**PROPOSED RESIDENTIAL DEVELOPMENT,
FORMER LILLEY AND STONE HIGH SCHOOL LONDON ROAD NEWARK, (3876)
APPLICATION REFERENCE PREAPM 00260 23
RESPONSE TO NOTTINGHAMSHIRE COUNTY COUNCIL COMMENTS - DECEMBER
2023**

This note has been prepared in response to comments received from Nottinghamshire County Council (NCC) dated 24th November 2023.

The comments concern the Transport Assessment (TA) submitted in October 2023 in support of PREAPM 00260 23 for Full Planning permission for Demolition of existing buildings, conversion of 3 no. retained heritage buildings to provide 32 apartments and erection of 43 new dwellings including access, parking and landscaping; and Outline planning permission for the erection of up to 64 new dwellings (all matters reserved except access) at the former Lilley and Stone High School, London Road, Newark.

DRAWING NUMBER: 3876-SP03	REVISION: -
-------------------------------------	----------------

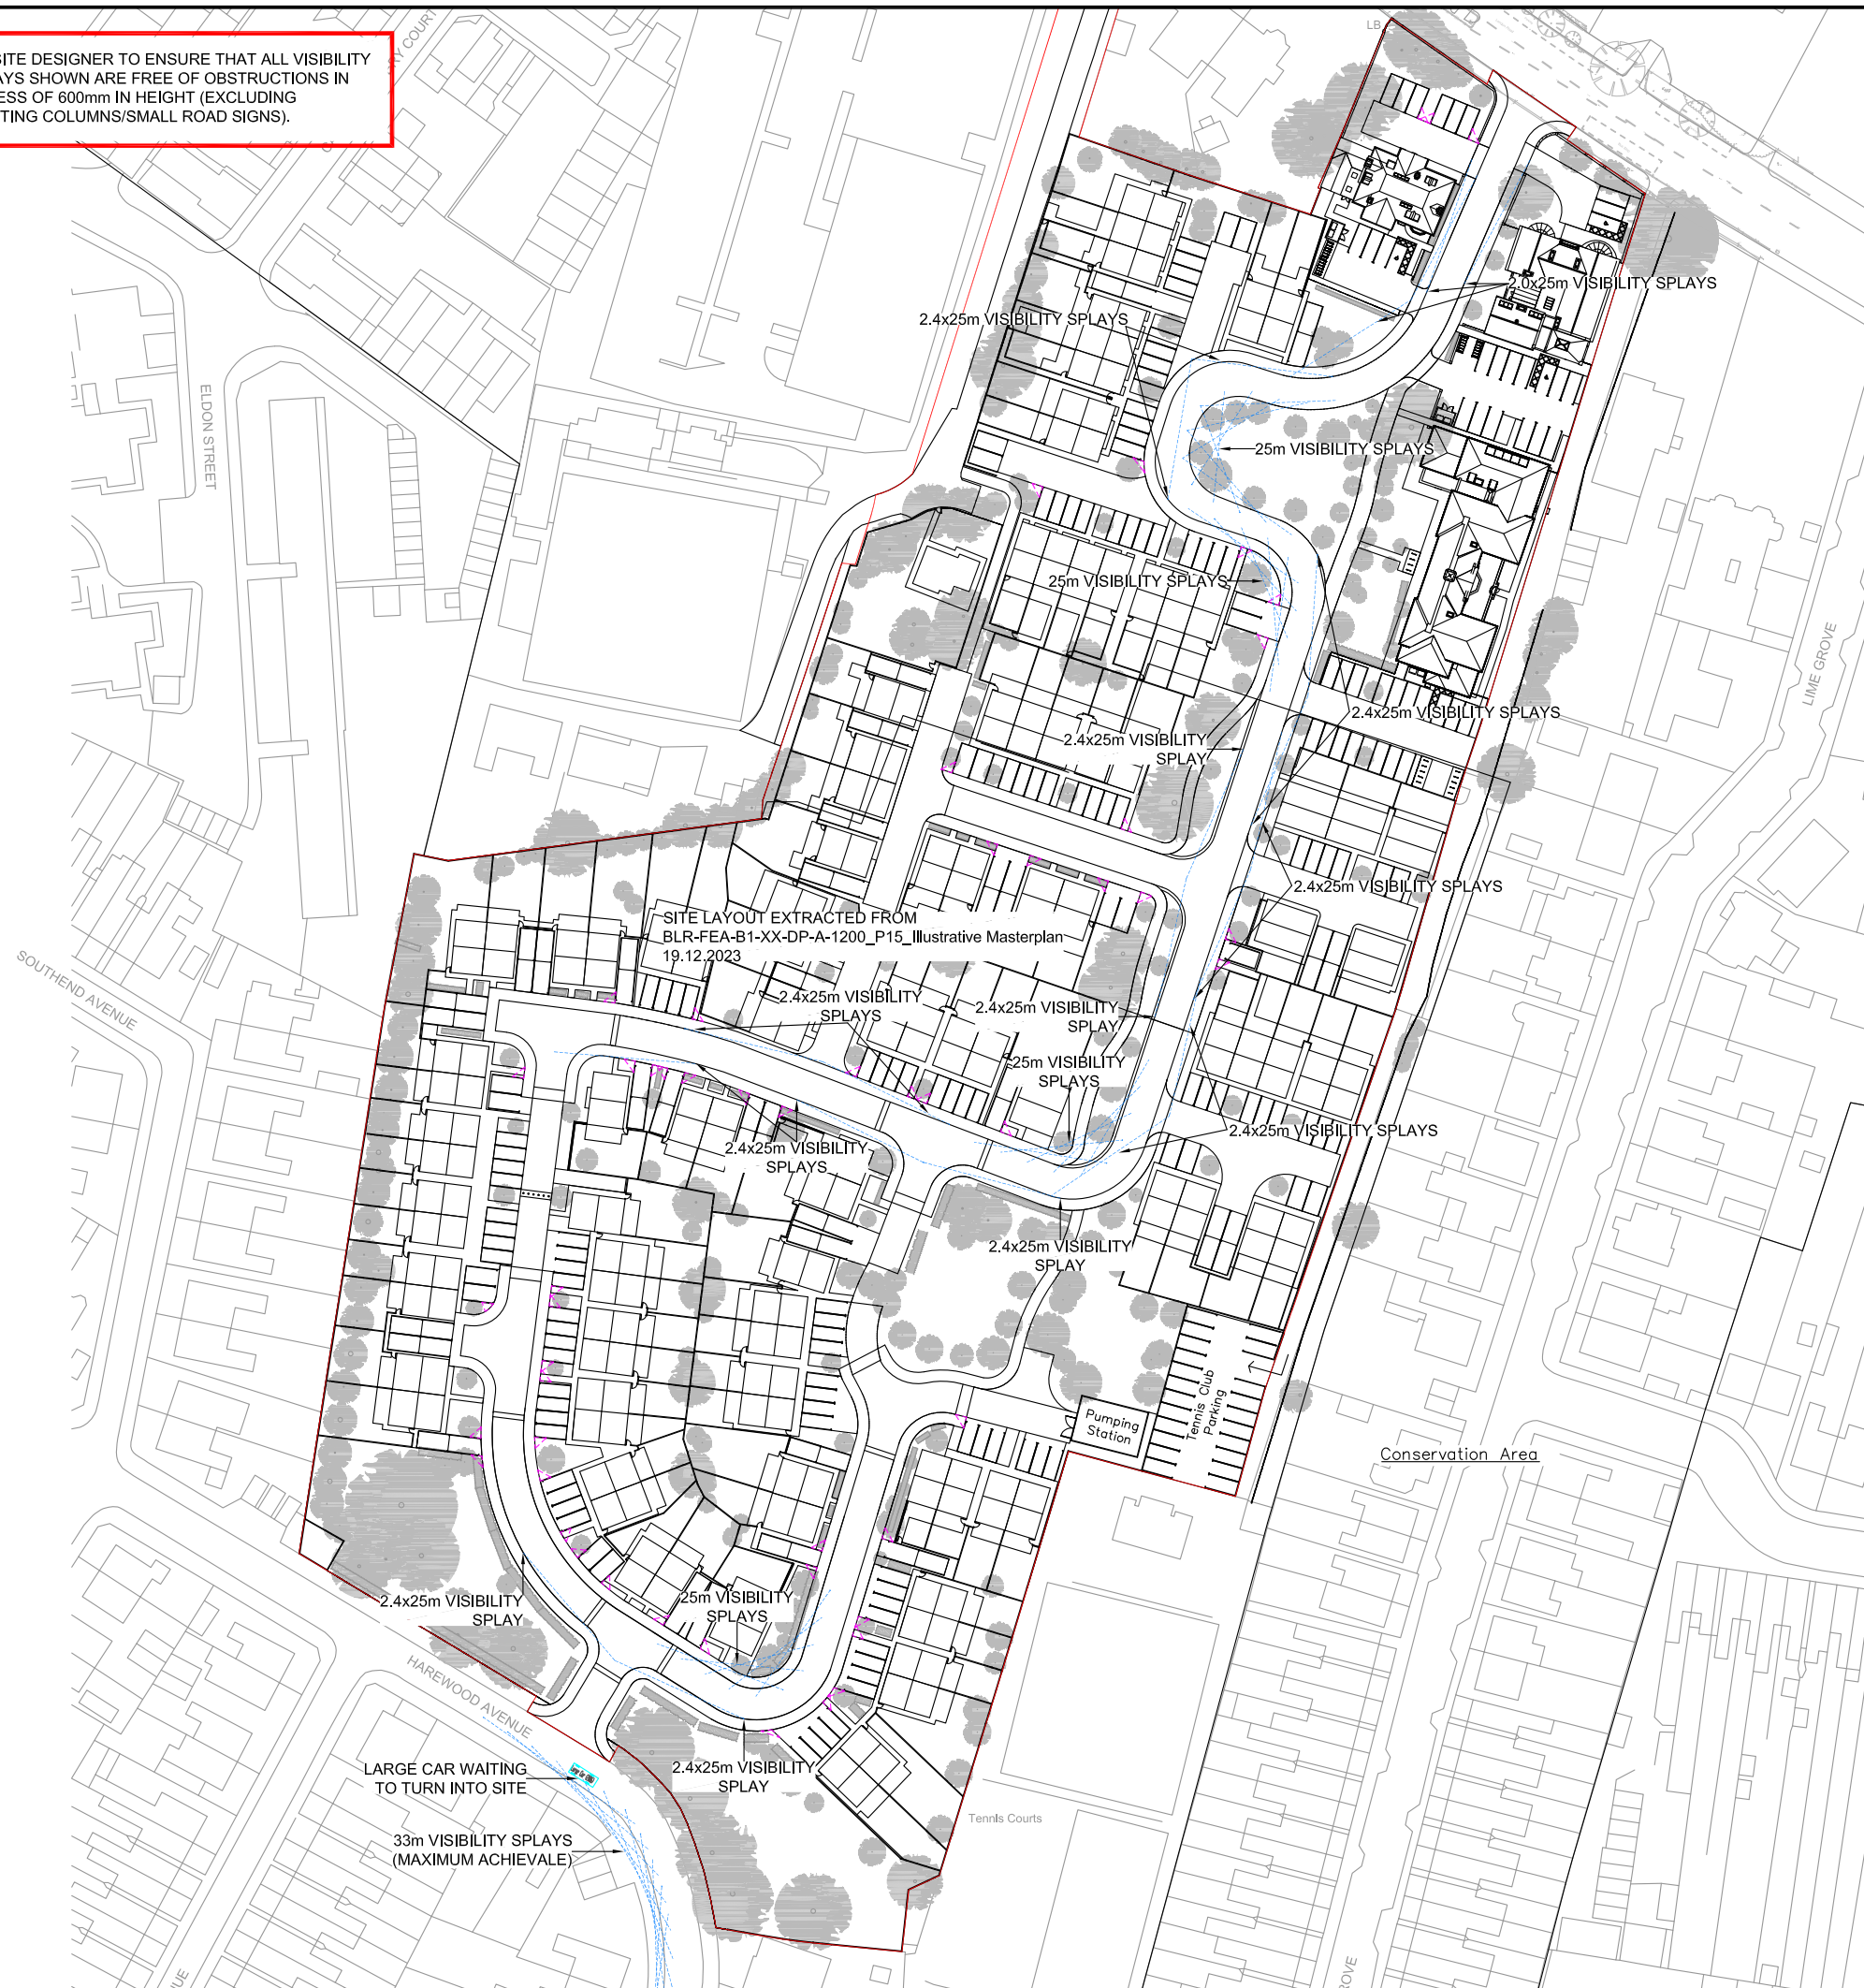
- **There is no widening on the bends. This should be determined by tracking a large car and a delivery vehicle, with suitable offsets.**
- **Pedestrian and vehicular visibility splays are required to be shown from all private drives serving 2 or more dwellings.**
- **Bin collection points are required close to the rear of highway and must not conflict with pedestrian visibility splays.**
- **Please note that the parking for the flats would need to be served by a dropped vehicular access as opposed to the bellmouths shown, to give pedestrian priority.**
- **Is the footway running north south across the Public Open Space to be offered for adoption? If not, the layout does not provide adequate footways.**
- **A service strip is required adjacent to carriageway but is not shown. A hard surfaced one would need to be 750mm, but grass ones are required to be 2 metres.**

- Swept-path tracking for a delivery vehicle and a large car has been undertaken as shown in **Drawing No. 3876-SP03**, there is sufficient road width (albeit using both sides), for a delivery vehicle and large car to pass one another with substantial forward visibility as shown in **Drawing No. 3876-01**. Furthermore, it is considered unlikely that large delivery vehicles will be travelling through the site at peak times or in significant numbers to raise a safety issue. Therefore, a condition requiring the height of landscaping to be kept to a maximum of 0.6-metres would be acceptable.
- Visibility splays are shown for all private driveways serving two or more dwellings, throughout the site, as shown in **Drawing No. 3876-01**.
- The provision of bin collection points will be addressed at the detailed design stage.

DRAWING NUMBER: 3876-F02	REVISION: C
------------------------------------	-----------------------

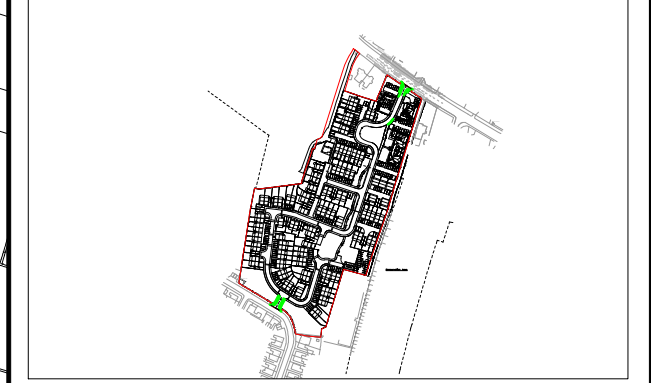
There are no drawings detailing the access geometry and these are required. However, the current proposal is for this to serve a leisure use (tennis club) and it (and the eventual subsequent road leading to the tennis club) would be required to be a minimum of 6m in width. It should also be established if Harewood Avenue is suitable for non-residential use.

As an access on an existing road, the required visibility splays should be supported by speed surveys, particularly as speed is an existing concern of a number of residents. Forward visibility of right turning vehicles should also be checked in view of this.

The southern site access will consist of a 5.5-metre-wide carriageway with 2-metre-wide footways running along both sides of the carriageway and 6-metre entry radii, as shown in Drawing No. 3876-F02 Rev C.

Speed surveys, to confirm the visibility splays, will be undertaken in conjunction with any additional traffic surveys once the study area has been finalised, following agreement of the development trip rates.

Figure 9 - North Site Development Traffic Flows (PCUs)

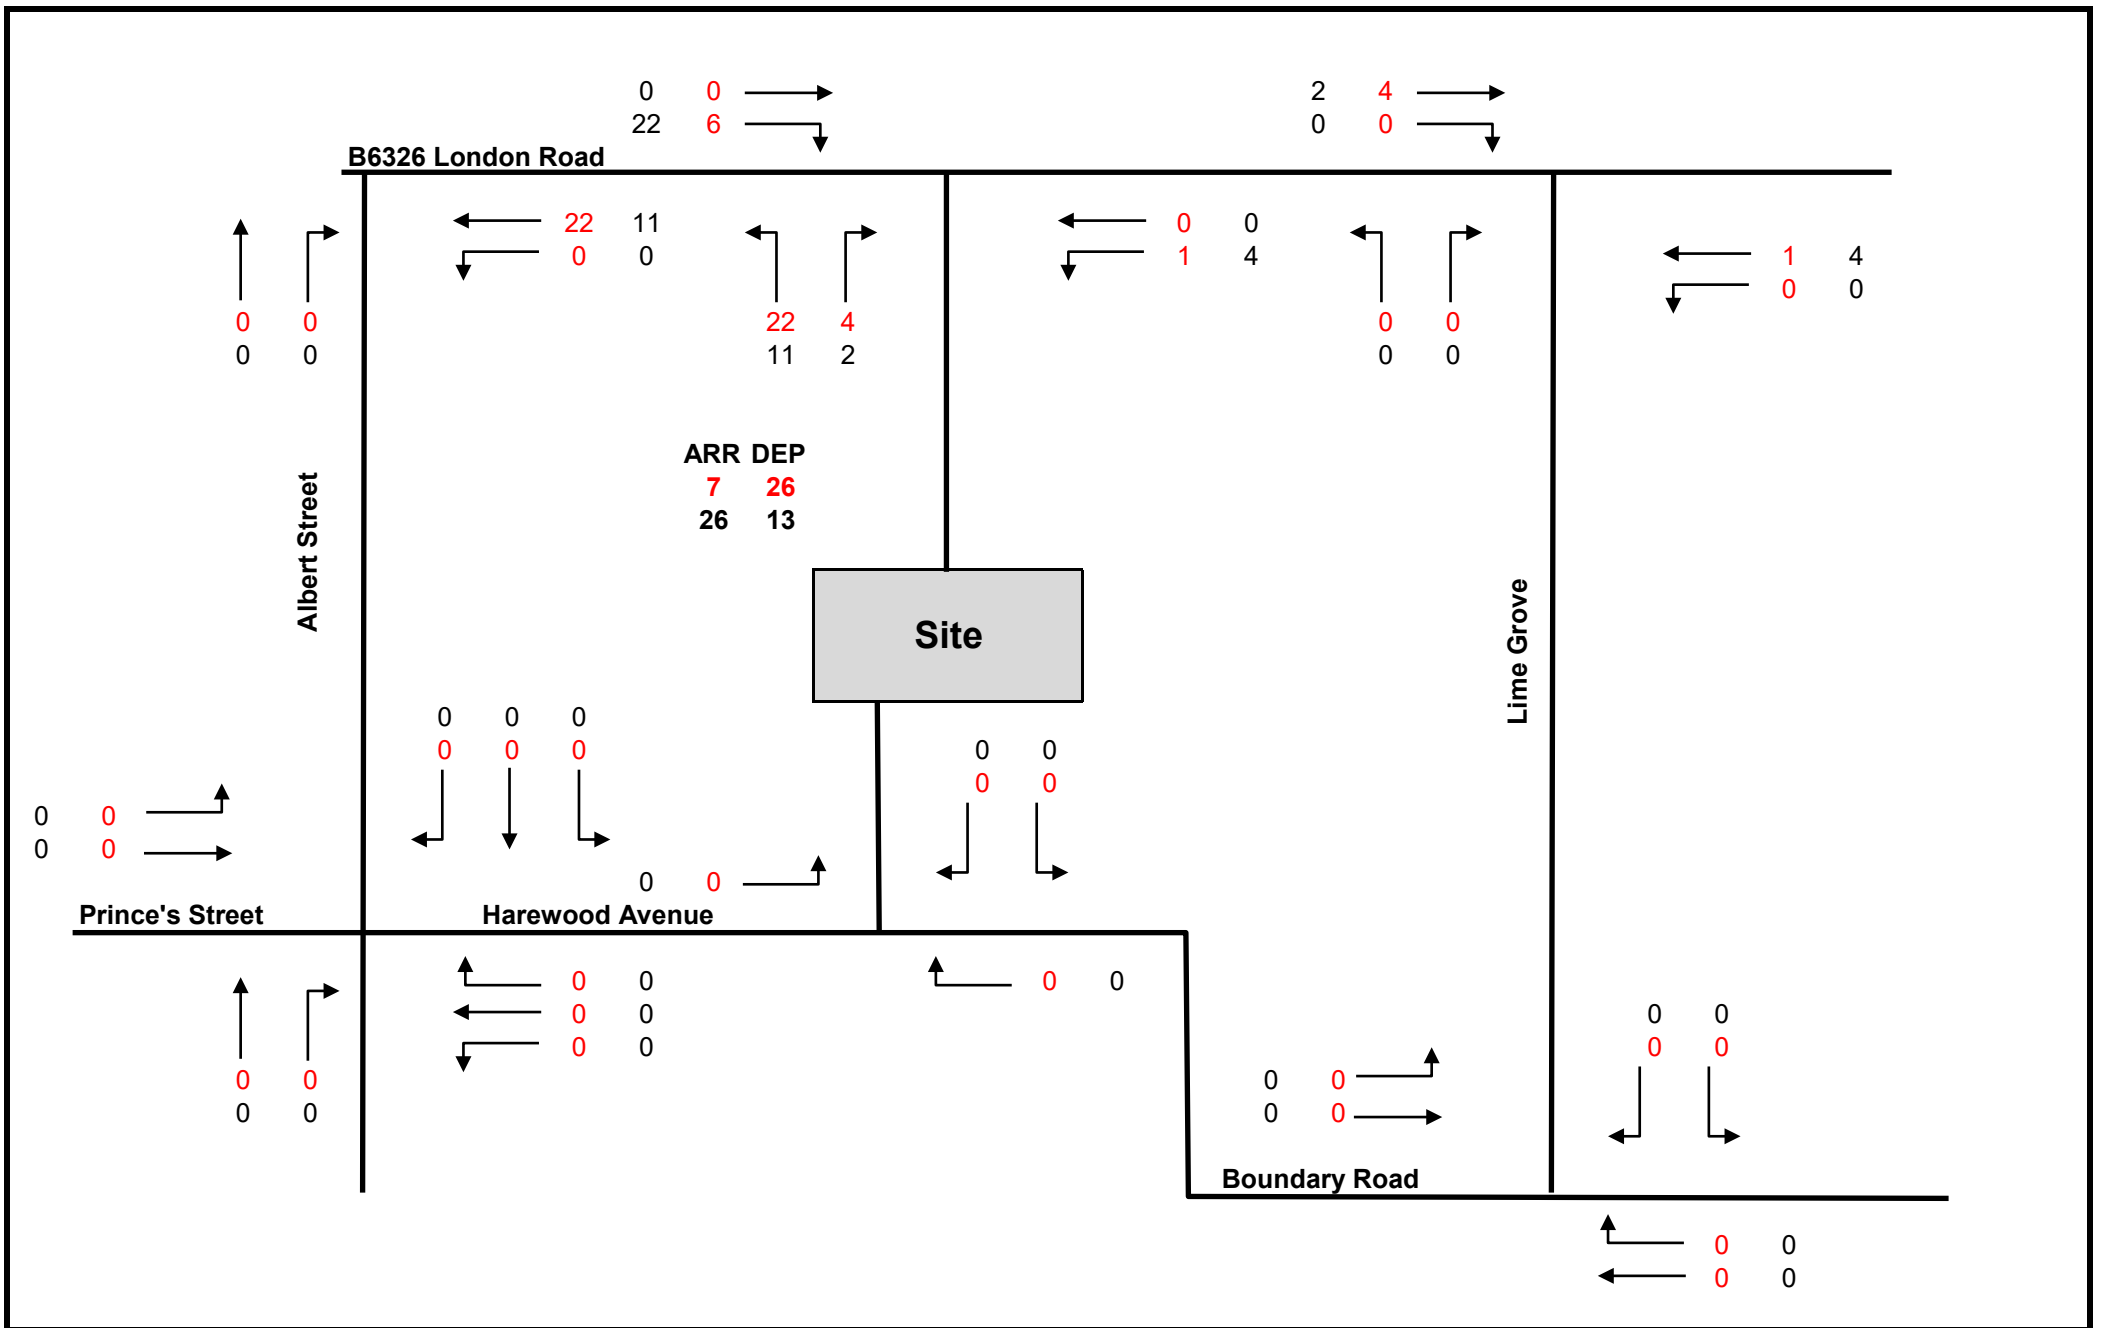
Notwithstanding the above issues, Figure 9 does not appear to show the correct figures as there is 1 less vehicle exiting the development in both am and pm peak.

This difference is due to rounding and is considered to be insignificant.

Figure 10 - South Site Development Traffic Flows (PCUs)

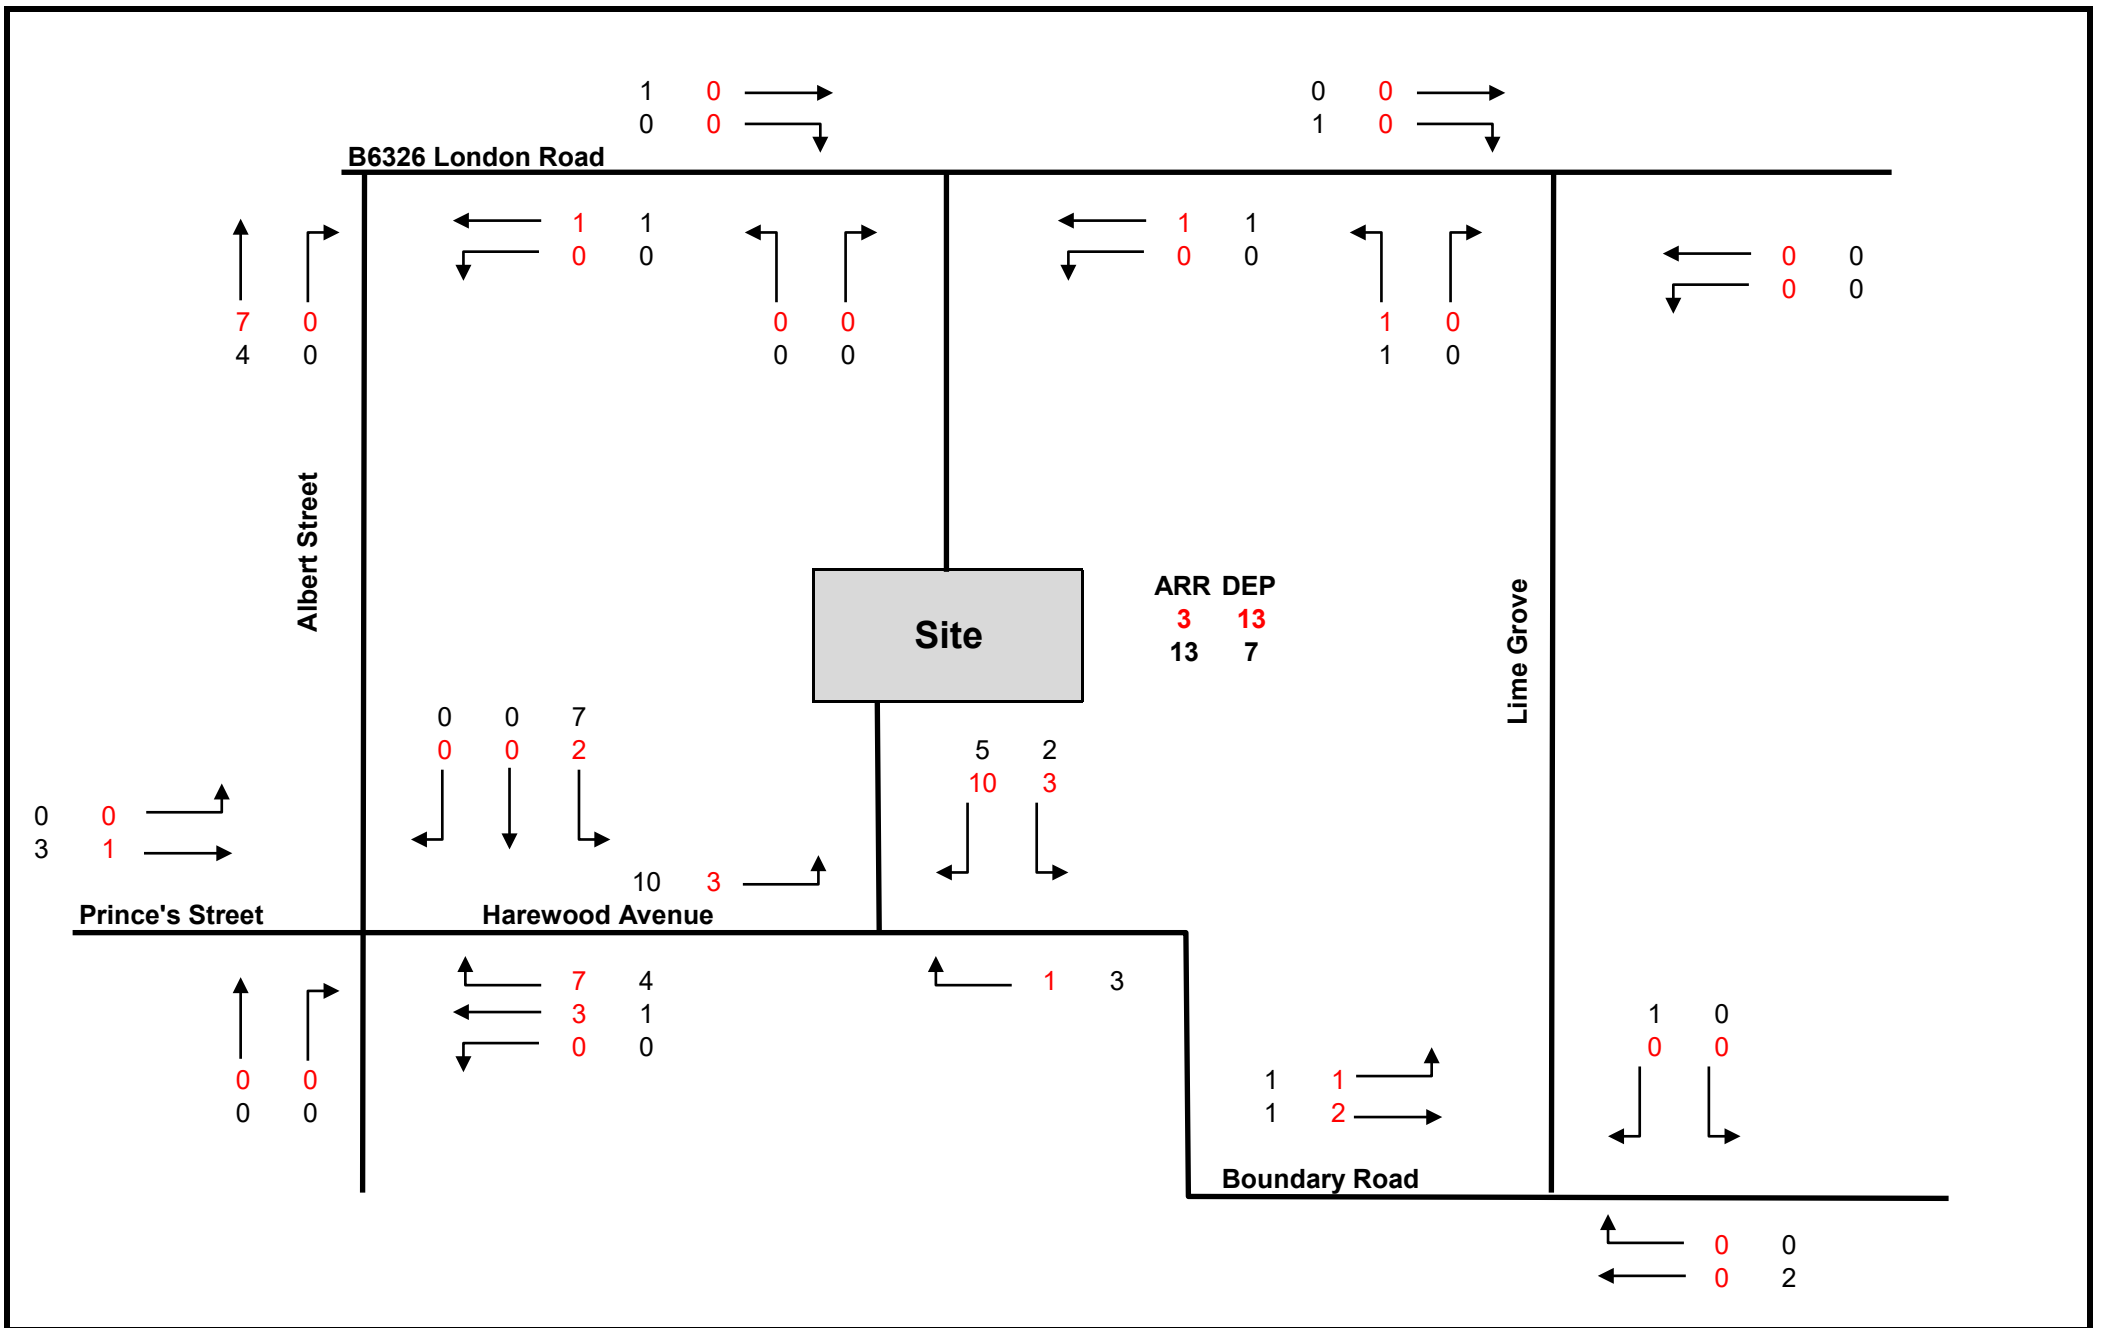
Considering Figure 10 which shows south site development traffic, there is a vehicle missing from the AM arrival, but moreover the tennis club has not been included. Whilst it is existing elsewhere on the network it should be considered as diverted and new to Harewood Avenue and the local junctions.

The single vehicle difference in the trip generation is due to rounding and is considered to be insignificant, as previously discussed.

As previously discussed, the Tennis club will continue to use their existing access onto London Road.
